### **On-Property Corrective Measures Implementation Construction Completion Report**

Subject:  
On-Property CMI Construction Documentation Report  
Koppers Inc. Superior, Wisconsin Facility  
WDNR BRRTs No: 0216000484  
WDNR Facility ID: 816009810

**On-Property Corrective Measures  
Implementation Construction  
Documentation Report**

Koppers Inc. Facility  
Superior, Wisconsin

**ATTACHMENT 1**  
FIELD ORDER NO. 001  
KOPPERS INC. FACILITY, SUPERIOR, WISCONSIN

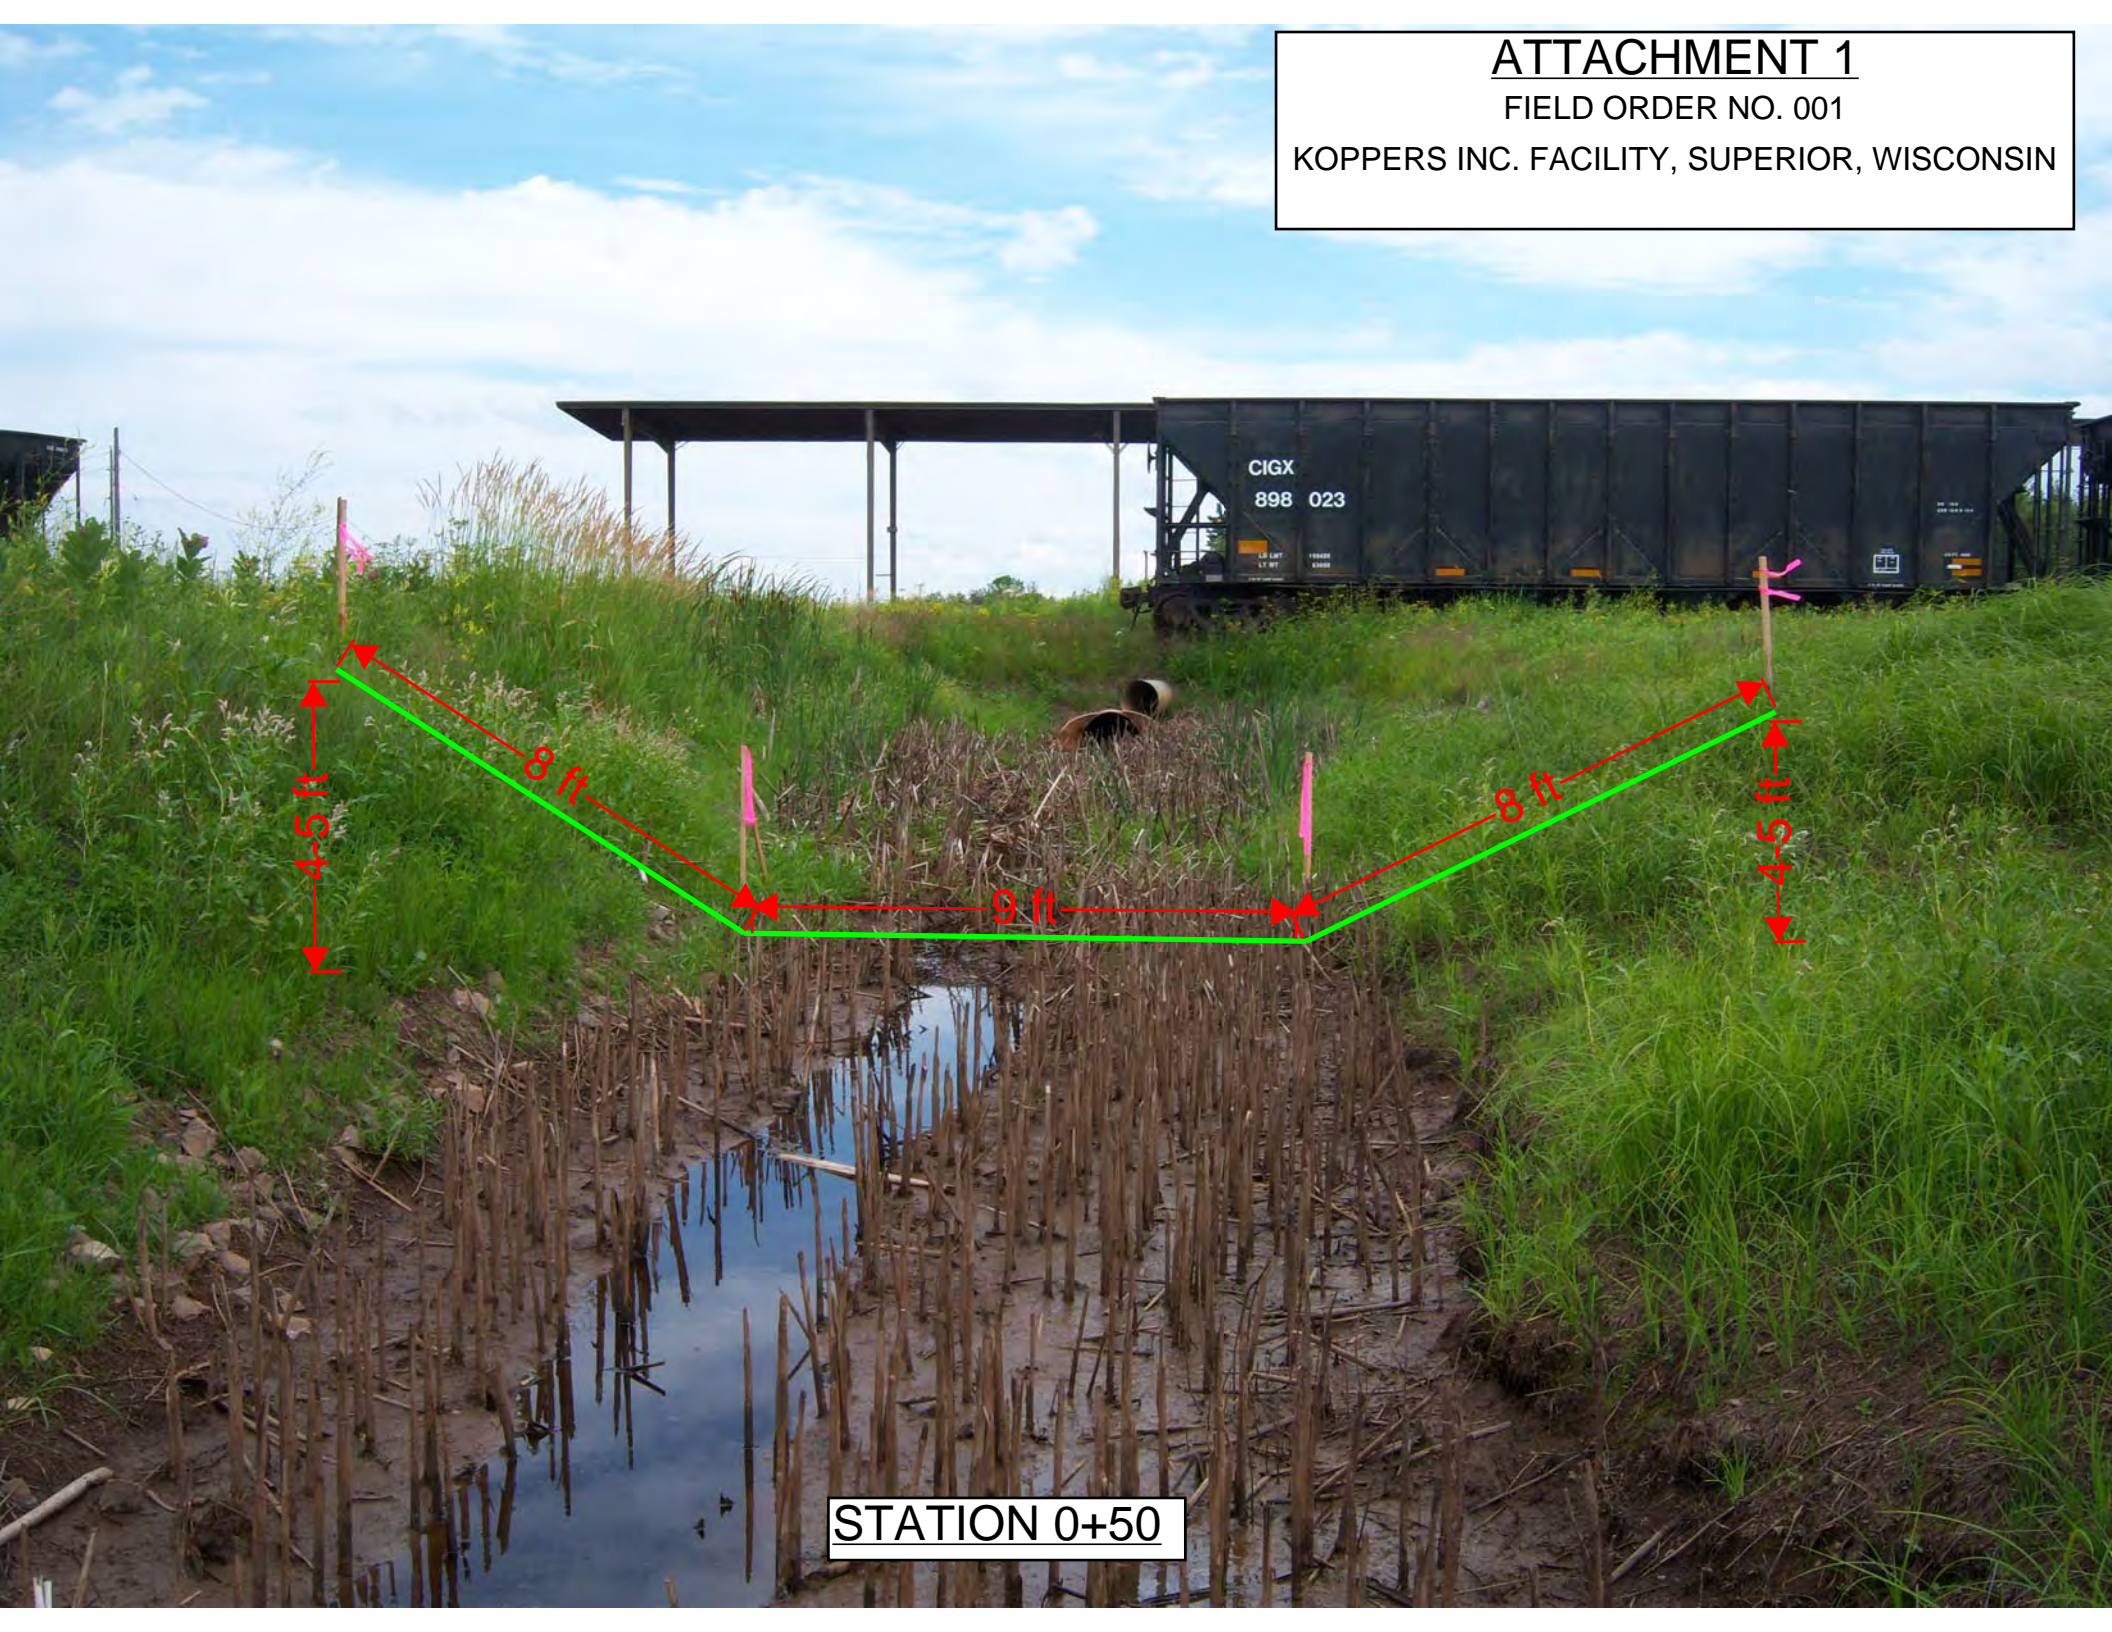
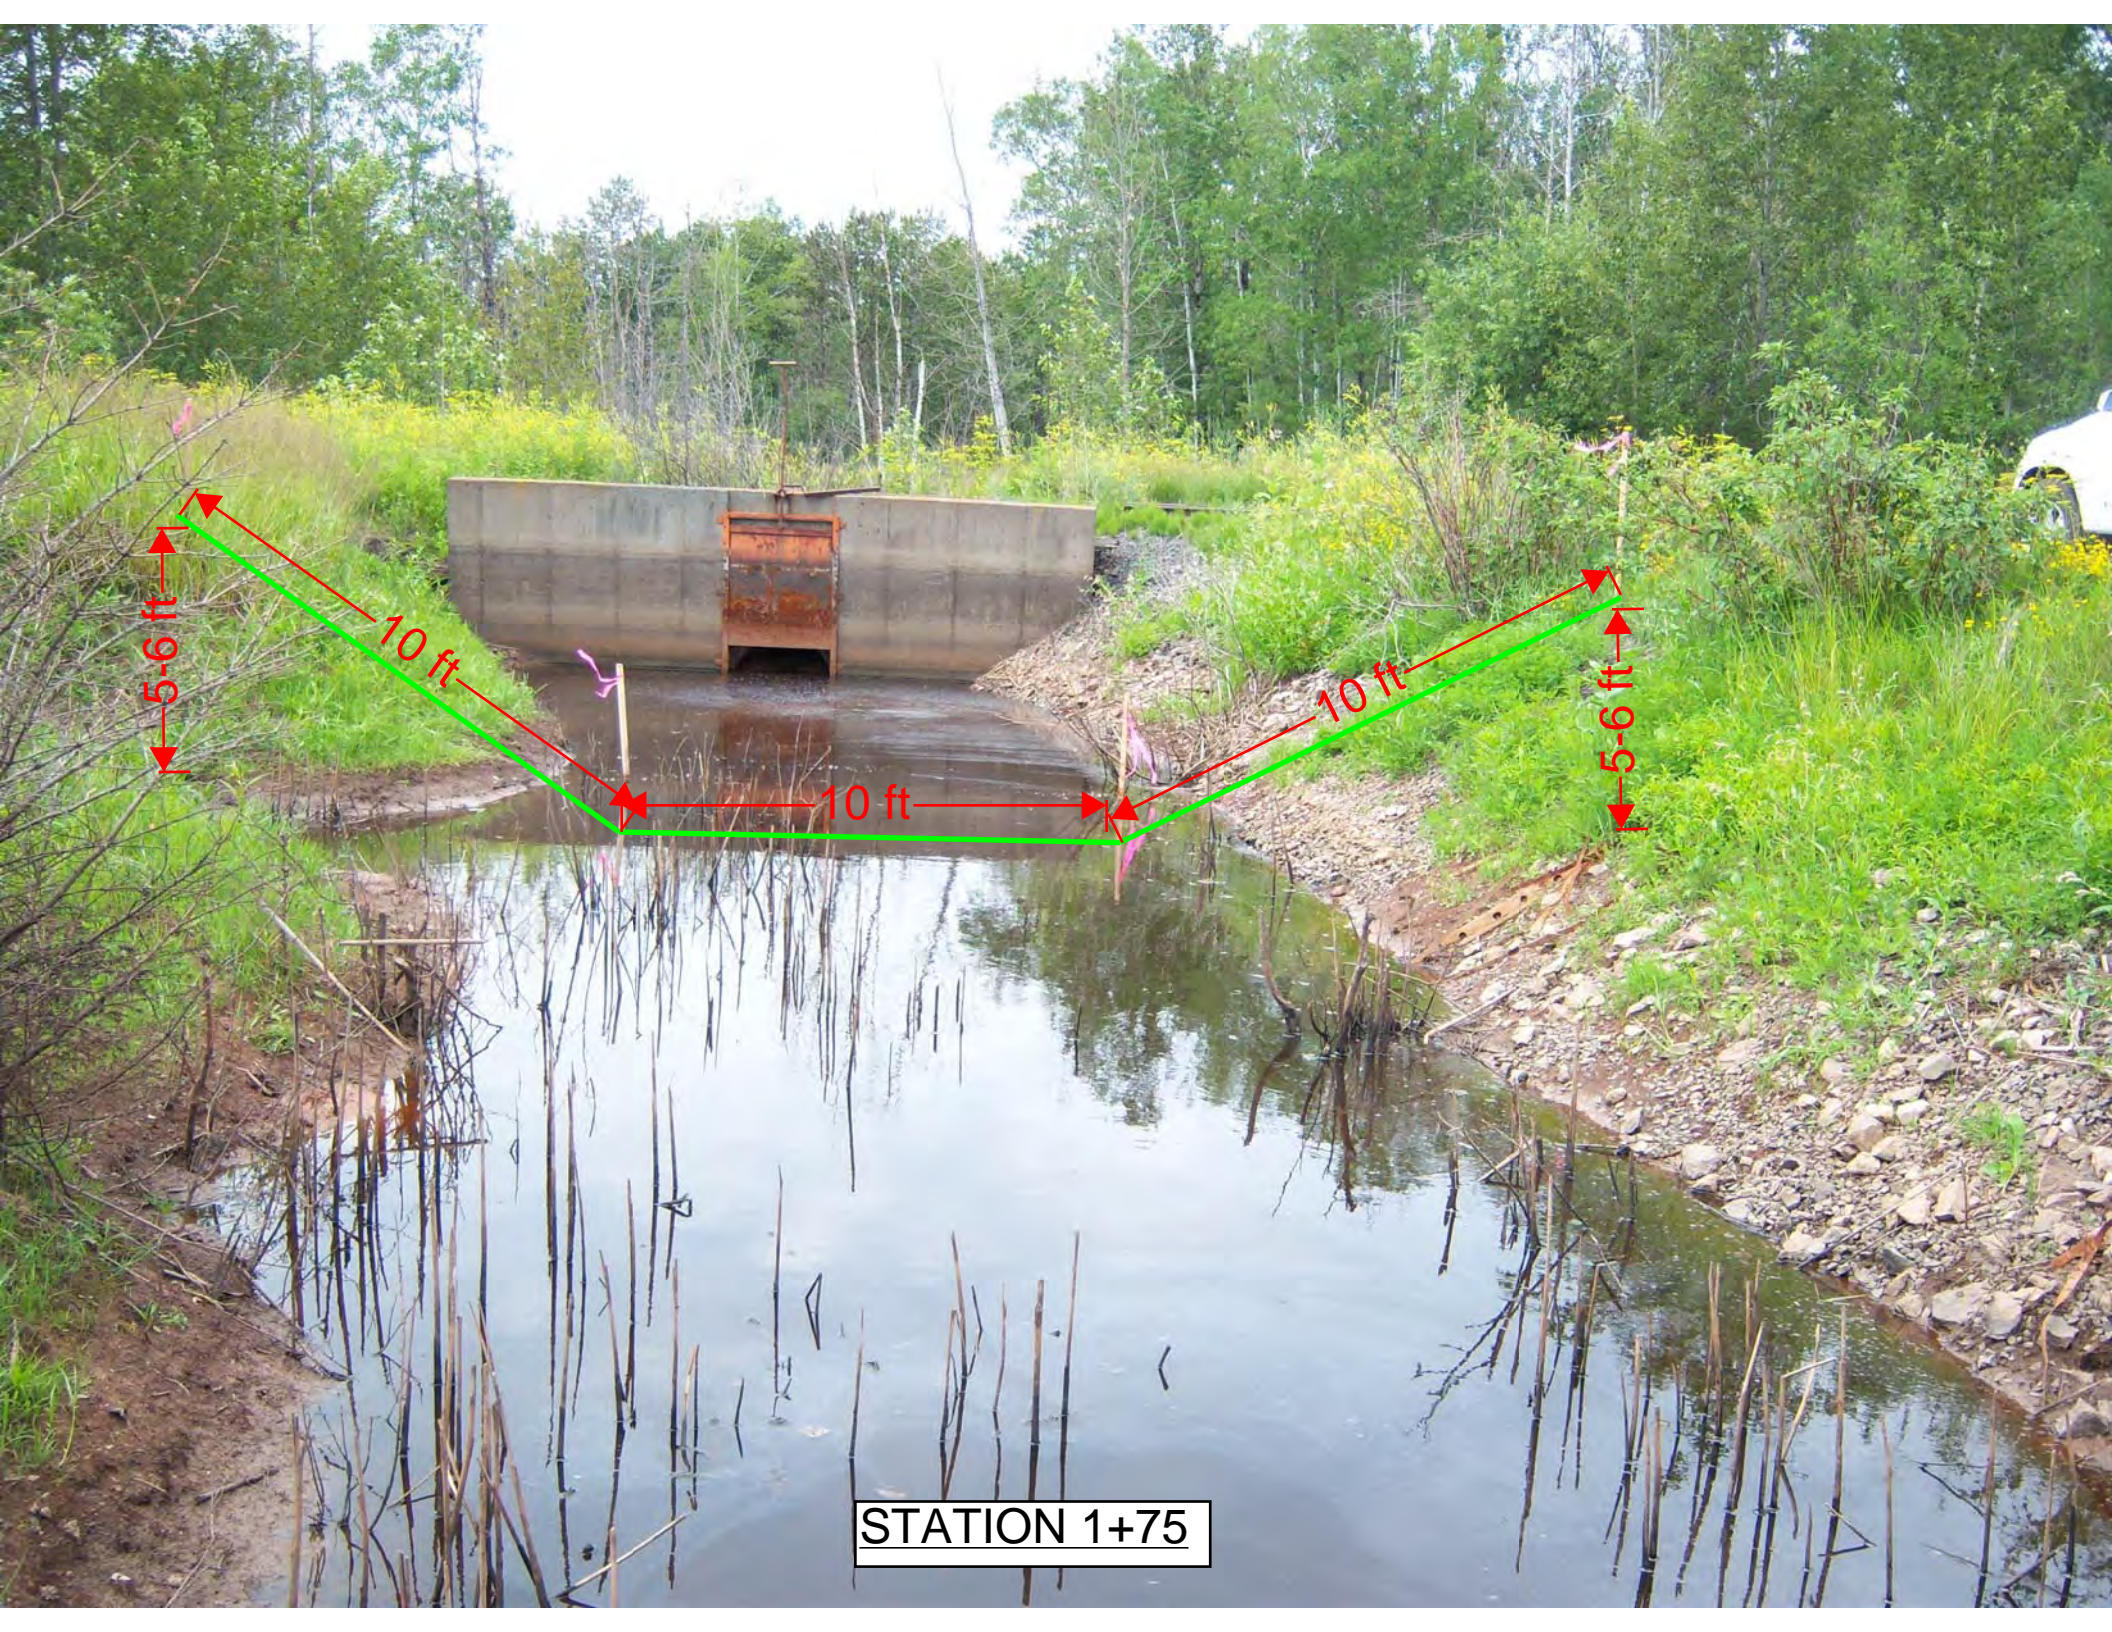
As discussed during the June 11, 2010 meeting at Severson's office in Delmont, Pennsylvania, due to high water in the Outfall 001 drainage ditch during the pre-design survey, the surveyor was unable to record the existing channel geometry. The typical on-property channel cross-sections depicted on Contract Drawing C301, which represent the minimum restored channel dimensions required to maintain proper Facility drainage, were used by Severson to determine the necessary quantities of the Outfall 001 drainage ditch restoration materials for their "Gray Book" Project Cost Estimate (Gray Book). Because the channel should not be filled with additional materials to achieve the minimum dimensions shown on Contract Drawing C301, the quantities of Outfall 001 drainage ditch restoration materials included in the Gray Book are potentially less than the actual required restoration material quantities. As an alternative to hiring a surveyor to conduct an additional survey of the Outfall 001 drainage ditch during lower-water conditions so that the restoration material quantities could be verified, Beazer decided to increase the Outfall 001 drainage ditch restoration material quantities by 30%.

During a July 13, 2010 site visit by ARCADIS, it was noted that the Outfall 001 drainage ditch water levels were low and the actual existing channel geometry at three locations was recorded. Photographs of these three transects and the existing channel dimensions are included as Attachment 1. As shown in Attachment 1, the existing channel dimensions, and therefore the restored channel dimensions, are increased from than the typical on-property channel cross-sections depicted on Contract Drawing C301.

ARCADIS calculated the quantities of all Outfall 001 drainage ditch restoration materials. The following table compares the quantities included on Contract Drawing C100 and the "Estimate Worksheet – Outfall Drainage Ditch Restoration" of the Gray Book with the estimated required quantities based on the existing channel geometry measured on July 13, 2010:

<b>Material</b>	<b>C100 Quantity</b>	<b>"Gray Book" Quantity</b>	<b>Revised Quantity</b>
Pea Gravel	--	390 ton	306 cy <sup>1,2</sup>
Reactive Core Mat	--	1,850 square yards (sy)	2,377 sy <sup>3</sup>
General Fill	--	240 cy	344 cy
Non-Woven Geotextile	--	20,800 square feet (sf)	28,405 sf <sup>3</sup>
R3 Riprap	900 cy	1,170 ton	915 cy <sup>2</sup>
